CALIFORNIA COASTAL COMMISSION

A-5-LGB-18-0056 (MIURA)
JUNE 11, 2020

EXHIBITS

Exhibit 6 – Memorandum, Dr. Joseph Street

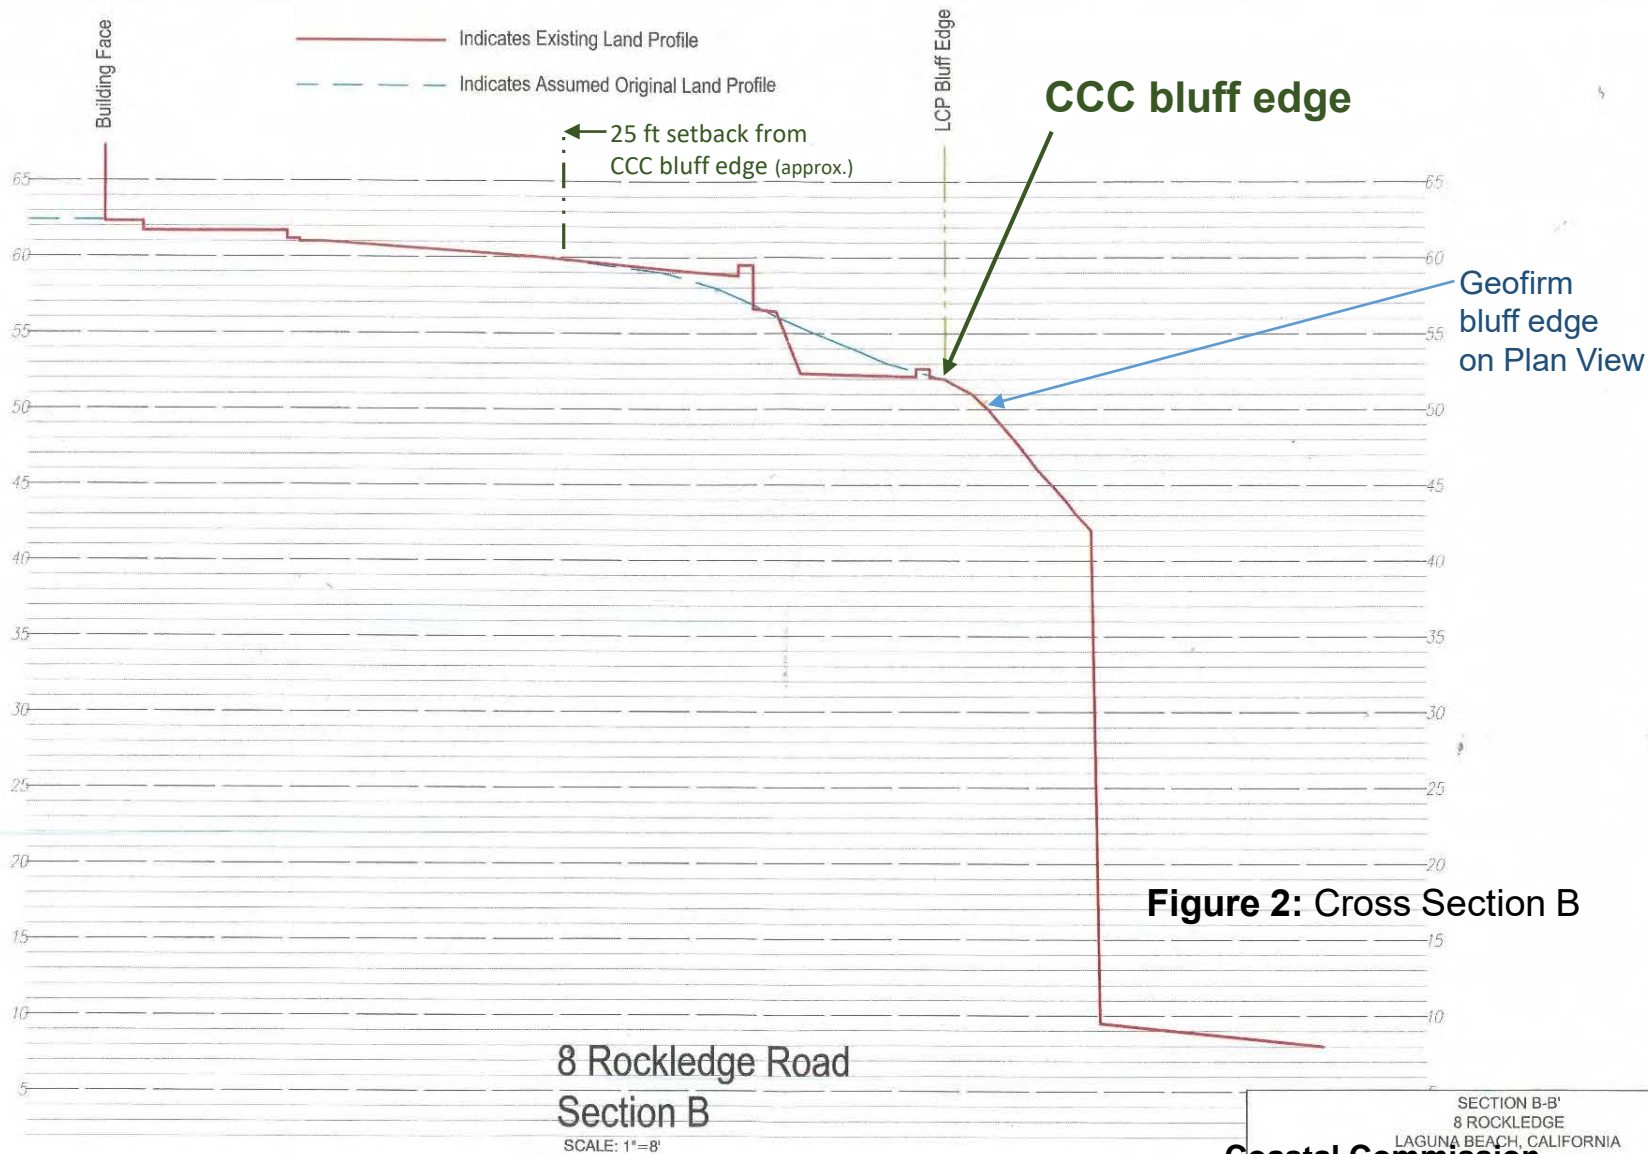
The purpose of this memorandum is to identify the location of the bluff edge on the subject property and to review slope stability and bluff erosion hazards at the site. My estimated bluff edge line is shown in Figure 1 (attached).

Figure 3: Cross Section A

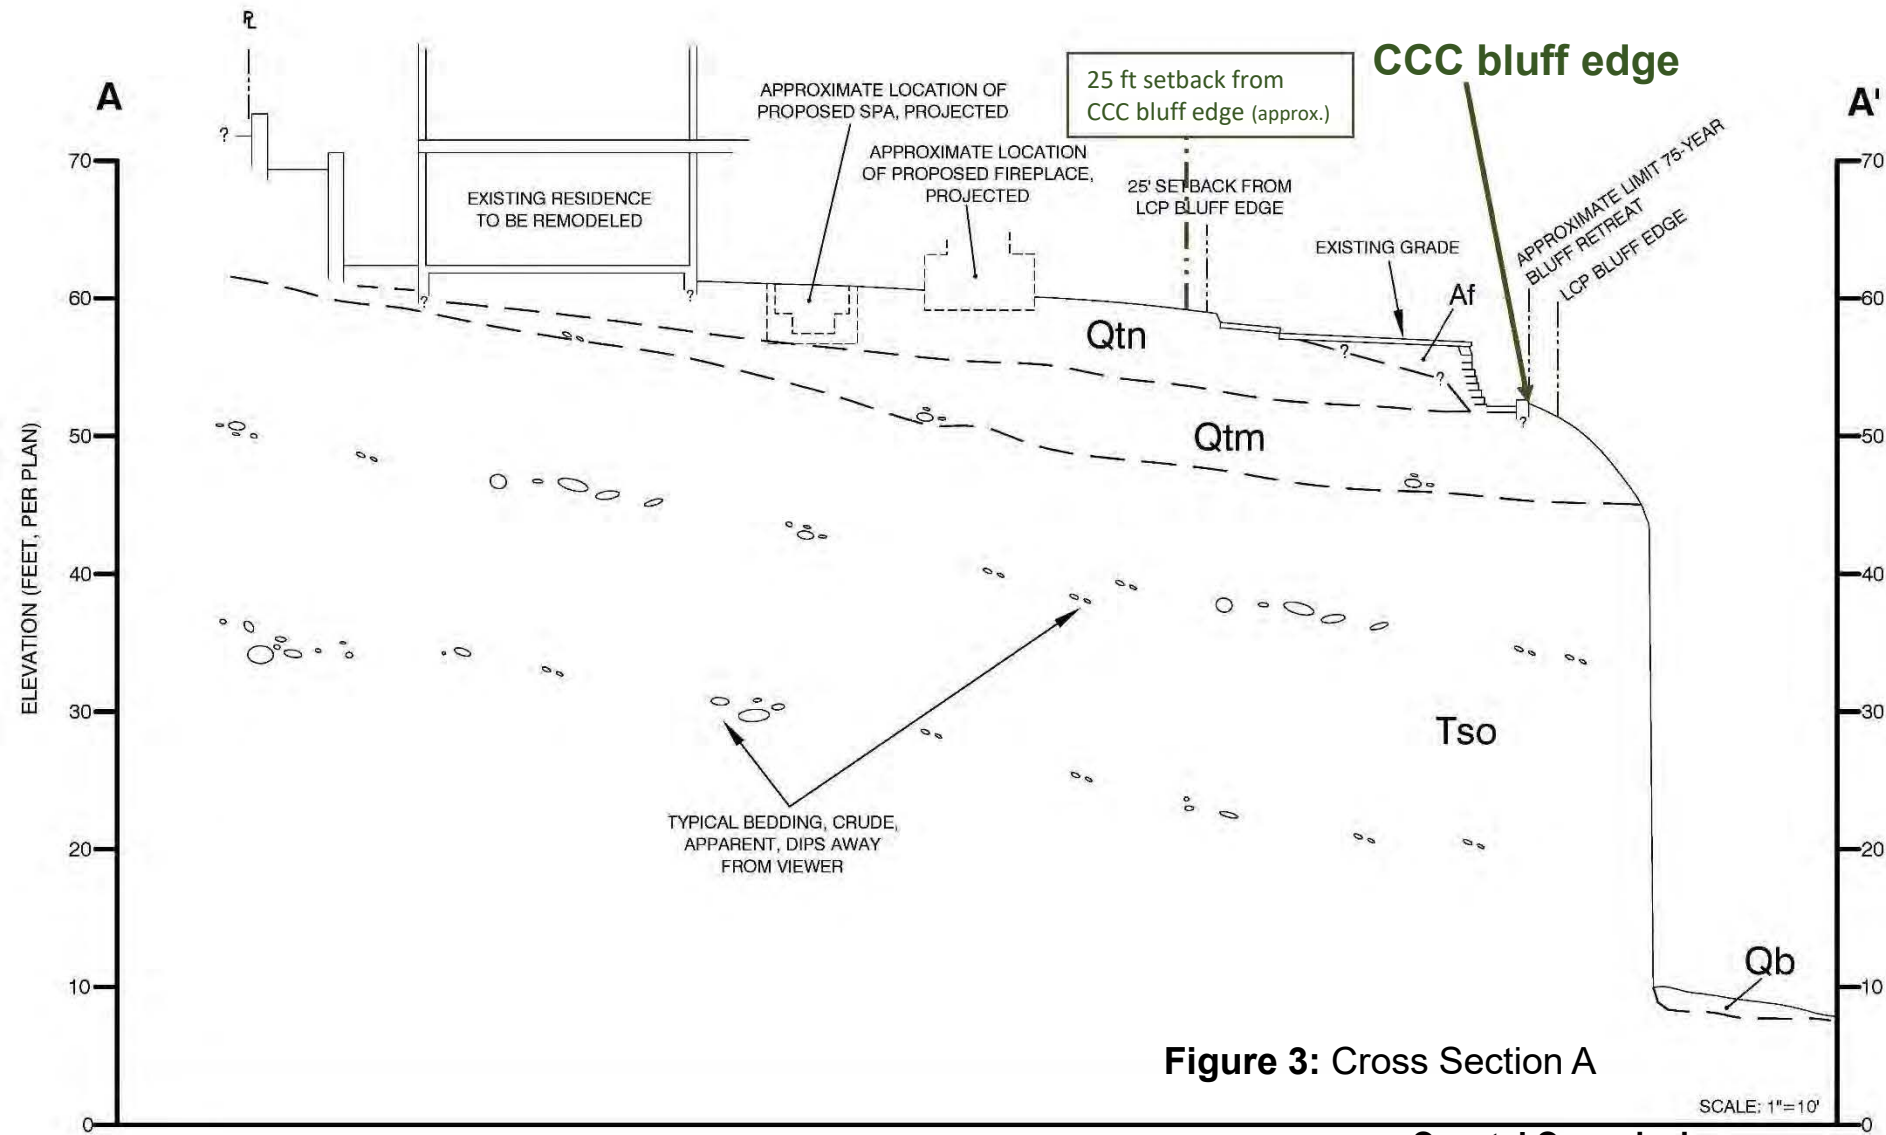
The coastal bluff at this site is affected by both marine erosion at the toe and subaerial erosion of the upper bluff deposits, resulting in a bluff top that, at its seaward edge, is rounded away from the seacliff (see Figs. 2-5). Refs. 3, 4, 6 and 7 identify a bluff edge line (“LCP Bluff Edge per City of Laguna Beach”, “LCP Bluff Edge”) between elevations +50 - 52 feet MSL. In plan view (Fig. 1, Refs. 3, 4 and 7), the applicant’s bluff edge line is located between 0 – 4 feet seaward of the curb of the seaward patio. However, this line does not consistently match the location of the bluff edge as identified in the site cross-sections provided in Ref. 7, where the bluff edge is shown as being two feet seaward of the edge of the patio in Section A-A’ and less than one foot seaward of the edge of the patio in Sections B-B’, C-C’ and D-D’ (Figs. 2-5). In all cases, the applicant’s consultant, Geofirm, locates the bluff edge seaward of the “step-like” feature created by the seaward patio and retaining wall.
